MEETING REPORT NO. 11

PROJECT: **Town of Needham Downtown Study**

DATE: 25 April 2007

- 1.1. The purpose of this meeting was to review a preliminary conceptual massing plan and alternative development scenarios. See attached presentation and markups. This discussion will be continued at the next meeting.

MASSING PLAN - Concept

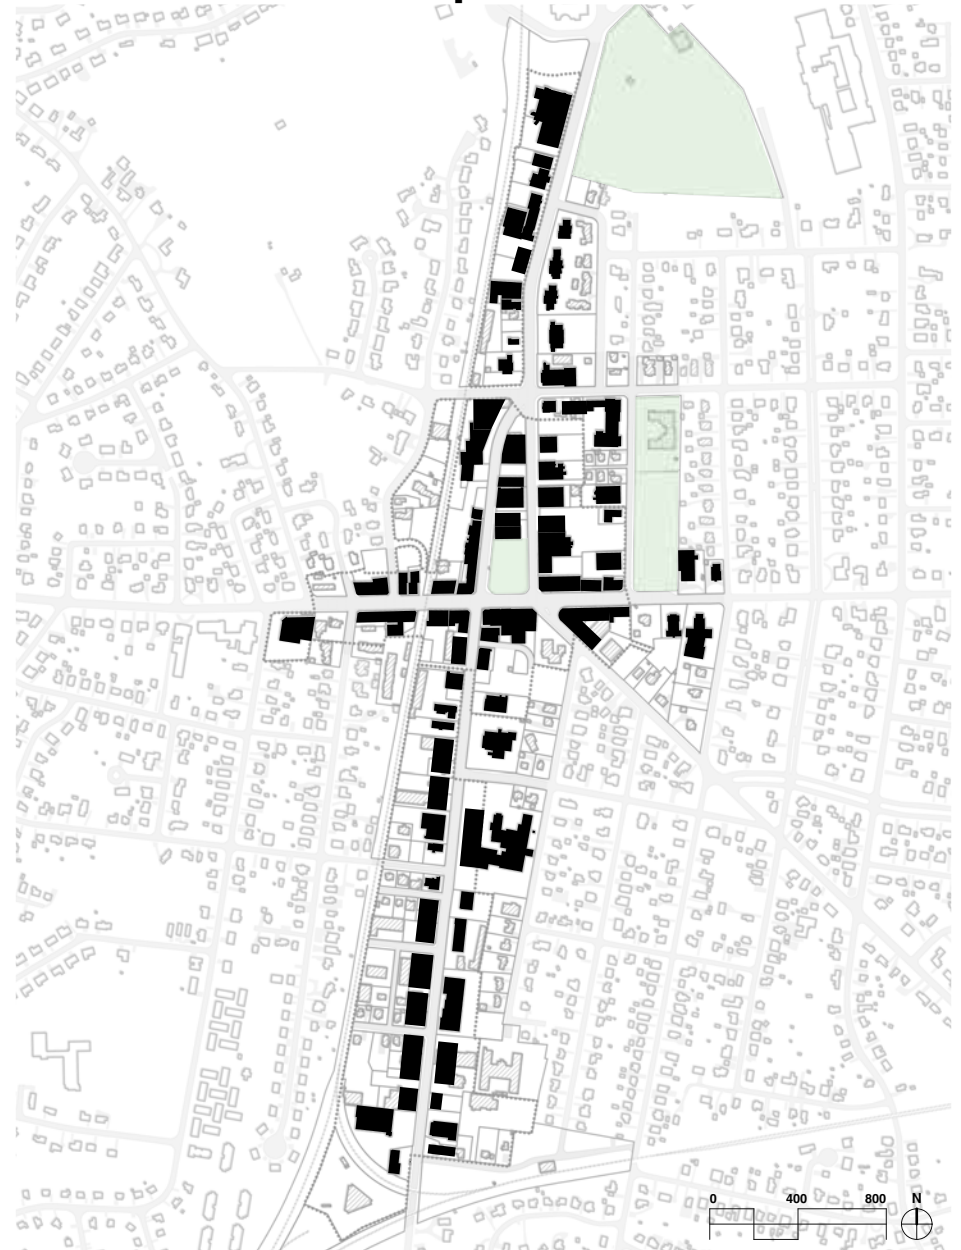
- 2.1. Concept – Existing and Proposed Figure / Ground Massing Plans of the Study Area were shown. The focus of the Proposed Massing Plan was to increase building mass along the primary streets, creating more defined edges and streetscape spaces.

MASSING PLAN - Density

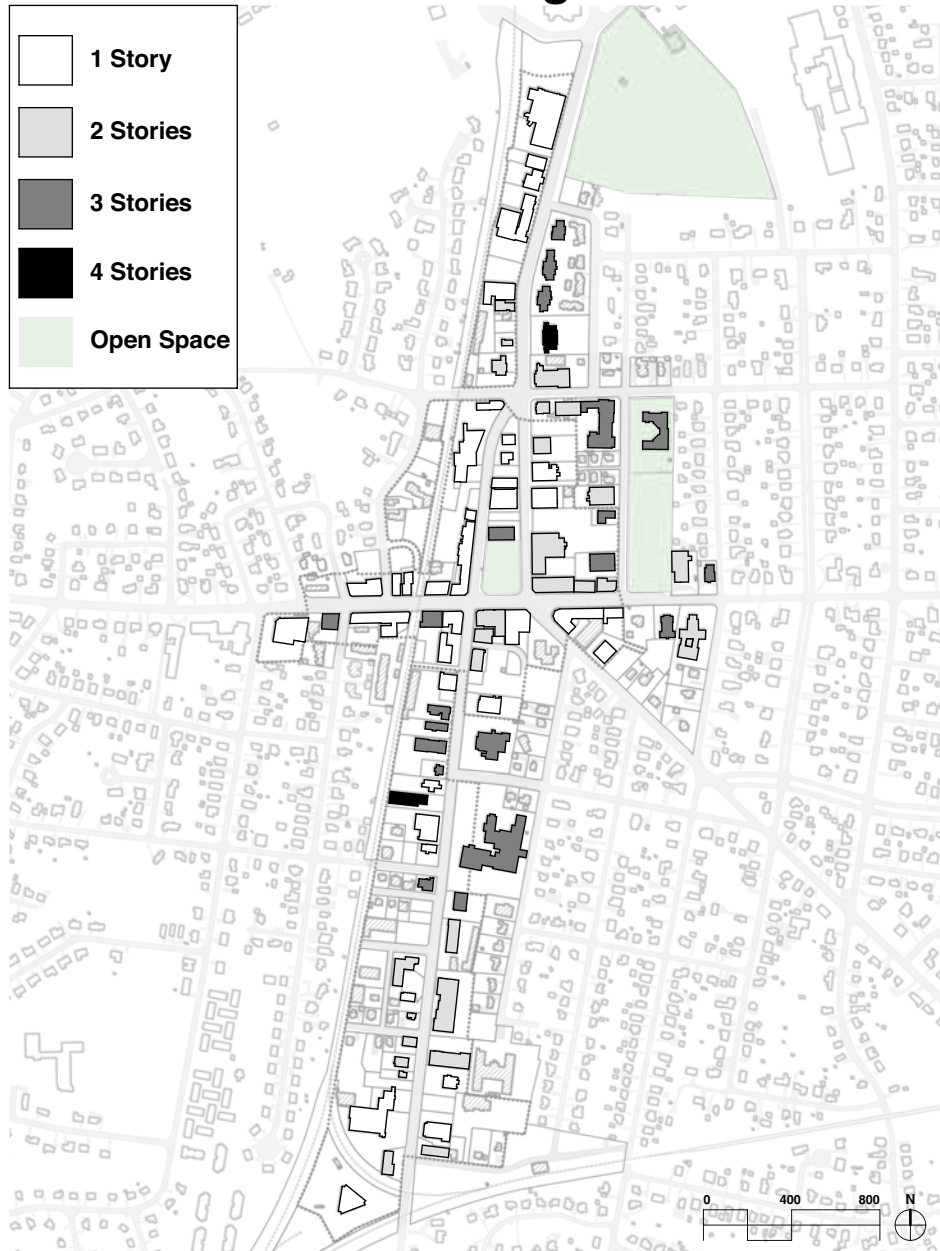
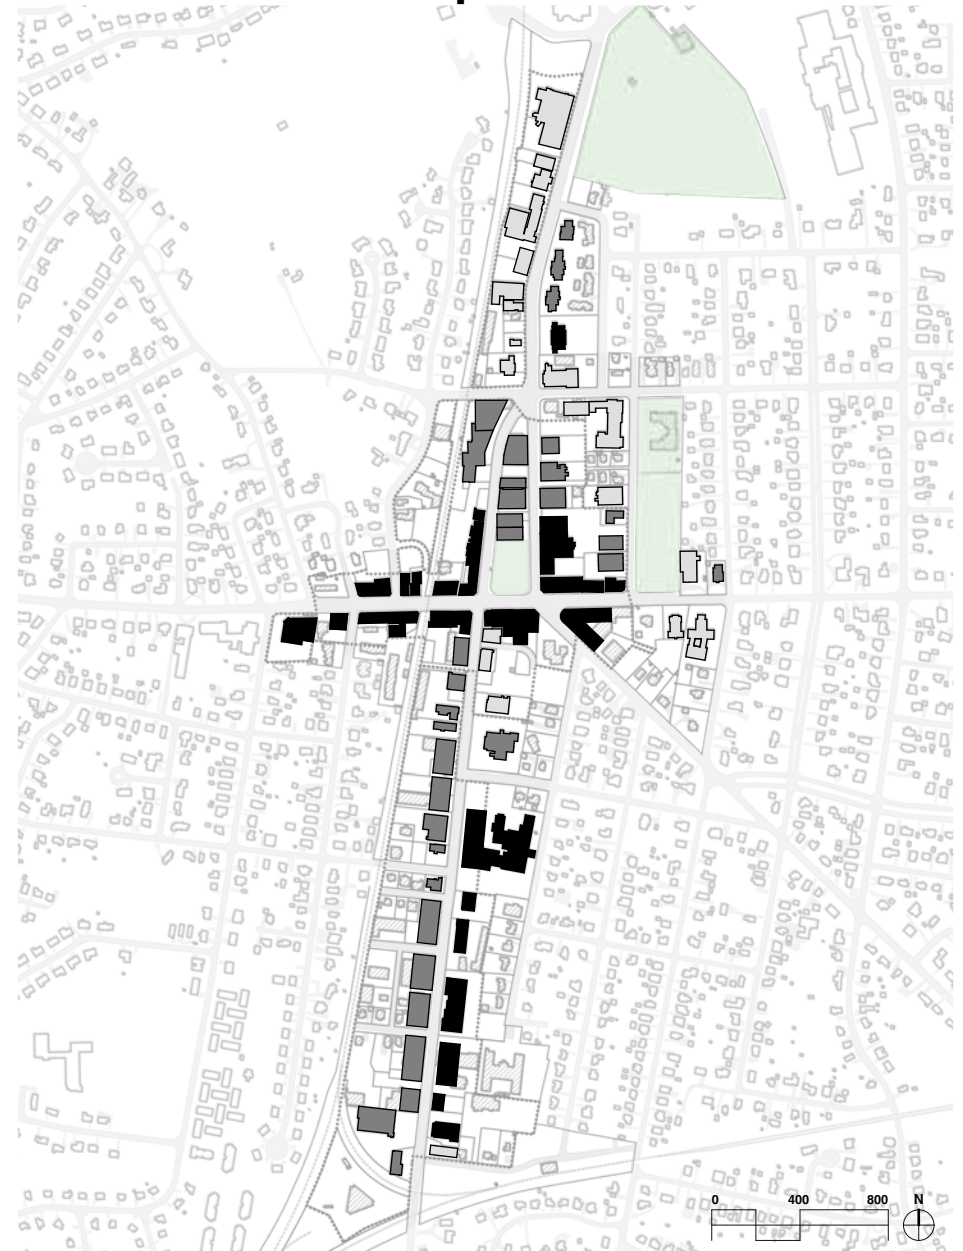
- 2.2. Density – The Existing Density Plan showed the downtown to be primarily one and two story buildings, with less three-story buildings and a few four-story buildings. The Proposed Density Plan, in contrast, showed a significant increase in three and four story buildings surrounding the Town Common; extending from the Town Common along Great Plain Avenue and along the east side of Chestnut Street from the Hospital south. A proportionate increase in three story buildings replaces one and two story buildings.

- 3.1. There were a variety of responses from DSC members regarding the conceptual plan presented:
- Proposed Increased Density
 - Why 4 stories? Are we maximizing for developer incentives or trying to enhance the village environment?

- Location of Increased Density
 - (Center Business District) Would prefer maximum 2 1/2 stories in place of the maximum 4 stories shown.
 - (Highland Ave Business District) Maximum height on west side of Highland Ave should match condos across street, on higher grade, effectively allowing three stories, when taking advantage of lower grade towards the back of these parcels.

- Buildings around the Town Common should not exceed the height of Town Hall.
 - In the 1990’s a zoning height restriction around Town Hall was eliminated.

MASSING PLAN - Density **Highland Ave Business District**

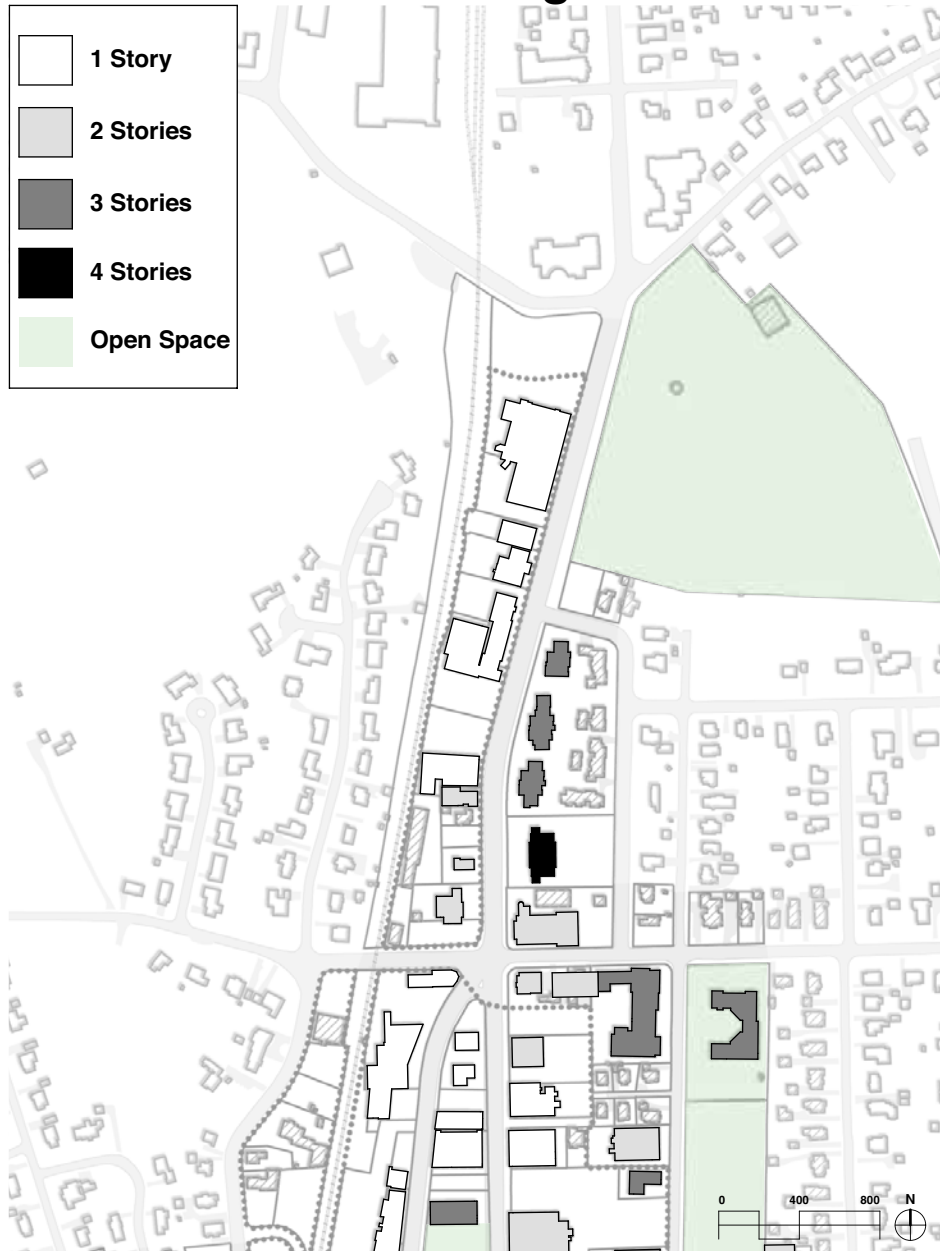
- 4.1. Massing Plan – Current zoning allows for maximum 3 story (40 FT) / no FAR maximum, (maximum lot coverage dependent on use). A previous study proposed 2 1/2 (story (35 FT) / 0.7 maximum FAR. The Proposed Density Plan shows an increase from existing one-story buildings to two stories. As discussed above, some DSC members said that a maximum of three stories is reasonable here on the west side of Highland Avenue, taking into account the topography, road width, and height of multifamily buildings on the east side of Highland. It could also help buffer noise from the commuter train line to the West. Specific comments from the DSC included the following:

- Gap at Bertucci’s – The Proposed Density Plan showed a building in the existing gap of buildings fronting on Highland Avenue next to Bertucci’s restaurant. The DSC raised the issue of the impact of this proposed massing on the Bertucci’s space which because of the proposed building would have less visibility on Highland Avenue. This impact would have to be addressed. One member of the DSC remarked that they didn’t mind the existing gap with a parking lot with planting strip at the lot frontage.

- One member of the DSC remarked that the plan for this Sub-Study Area should be for “beautifying” only.

- One member of the DSC remarked the office building next to Dunkin Donuts with parking in front was the most unsightly section of Highland Avenue in this district.

MASSING PLAN - Density Center Business District

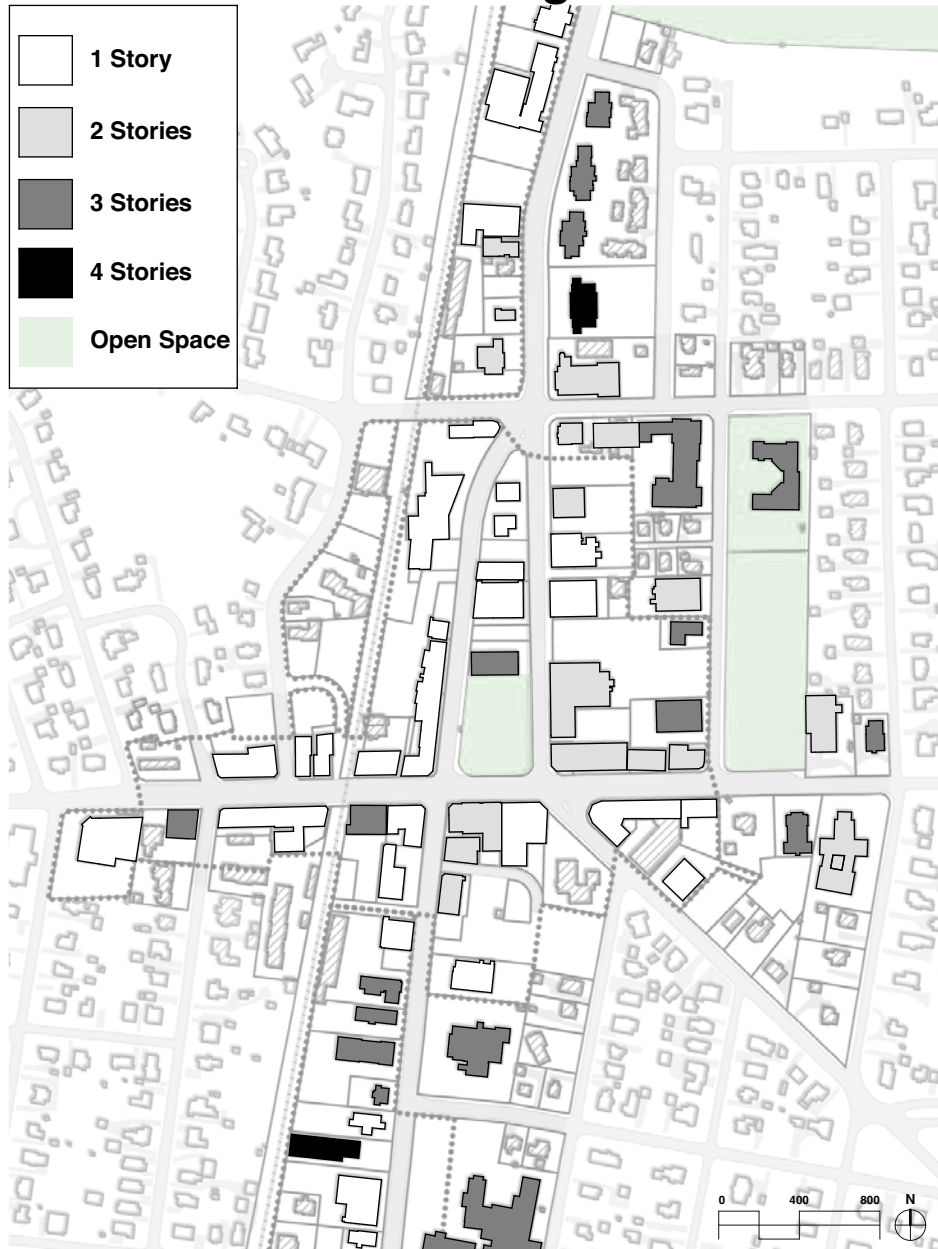
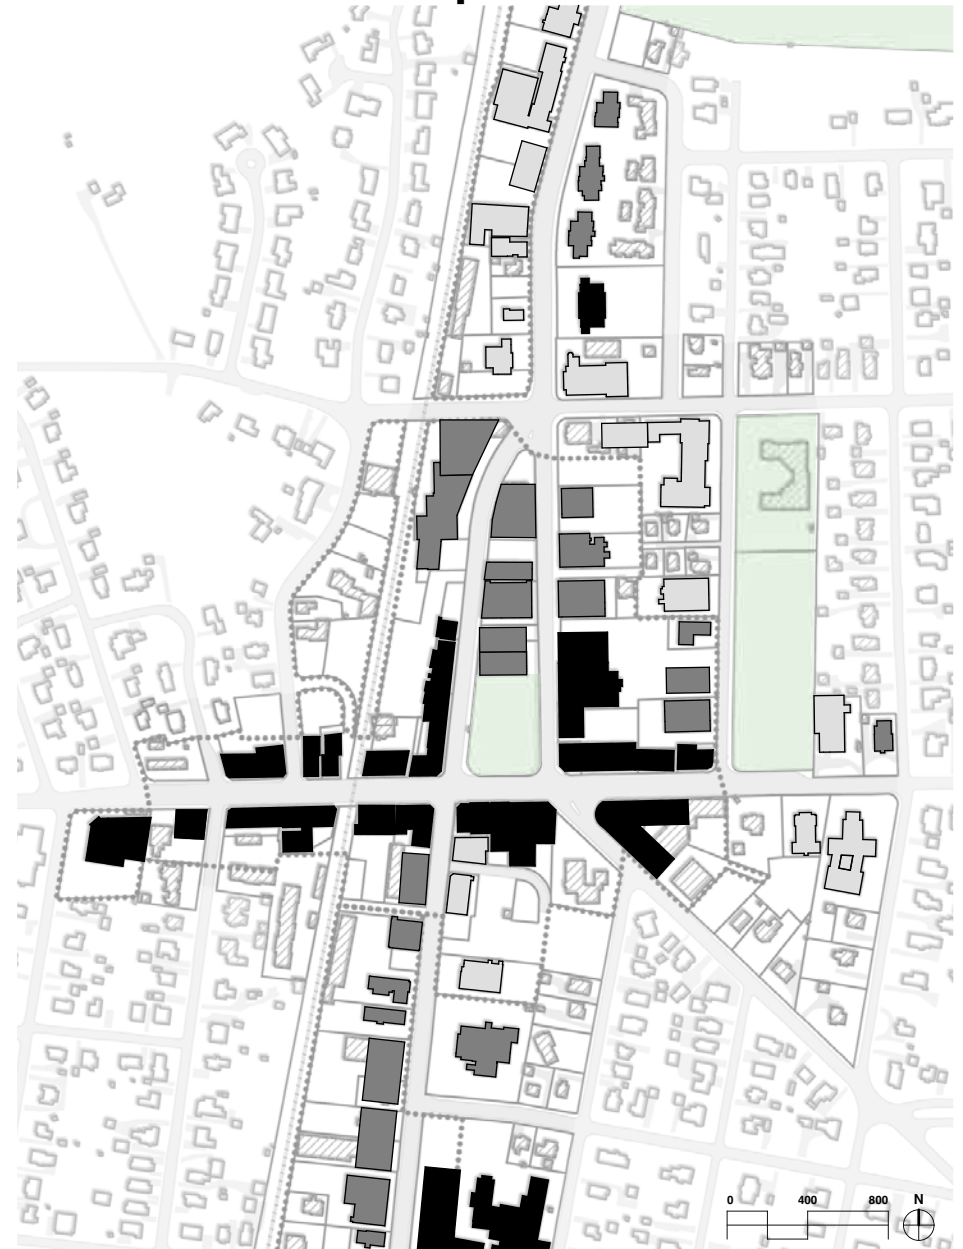
- Town Common – As discussed above there were mixed comments regarding the Proposed Density Plan showing buildings with a maximum four stories surrounding Town Common. The Town Common could benefit from a redesign to make better use of it.
- Greene's Field – Although not shown on the Proposed Density Plan, There is an opportunity for building at Greene's field along Great Plain Avenue. It was acknowledged by DSC members that there is a sentiment in Town to keep Greene's Field open at its Great Plain frontage.
- Theatre Block – This is a parcel whose new owner, Ken Macken, is evaluating his development options. DSC members generally agreed this site has the opportunity to be developed as a mixed-use project with housing. As discussed above this project could benefit from parcel assemblage with adjacent parcels.
